SERVICE BULLETIN

APPLICABILITY: 2017-18MY Forester 2.5L

NUMBER: 09-85-22

SUBJECT: Front Exhaust Pipe Cover Replacement

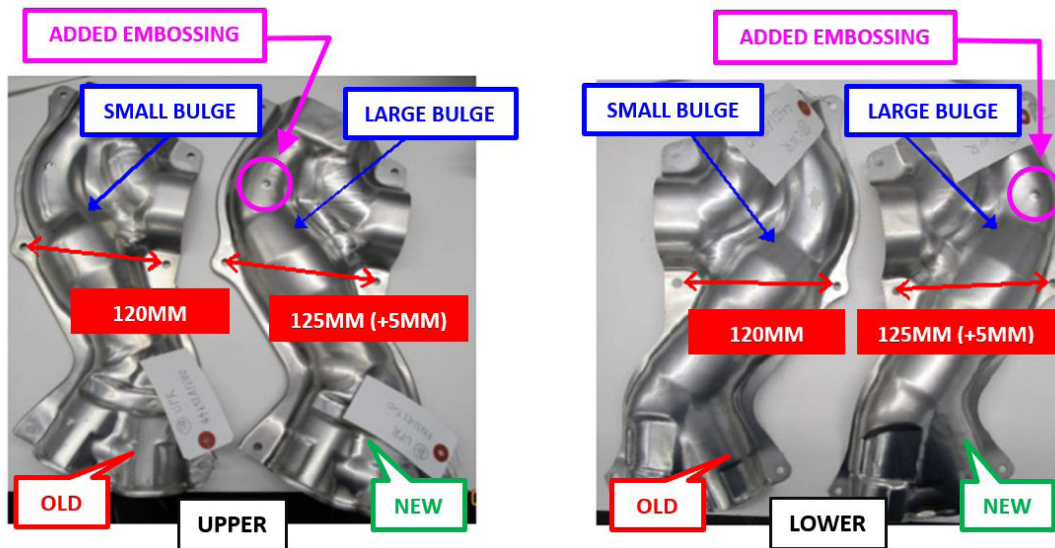
This bulletin announces design changes made to the front exhaust pipe covers. The covers have a re-designed shape to provide a more streamlined fit with the previously re-designed front exhaust pipe bellows.

- The parts listed above in gray are **one-time use** parts.
- If a situation occurs **where** one of the old-style covers need replacement, the covers **MUST** be replaced as a set. If the covers have BOTH been previously replaced with the new-style parts, they can be replaced individually.
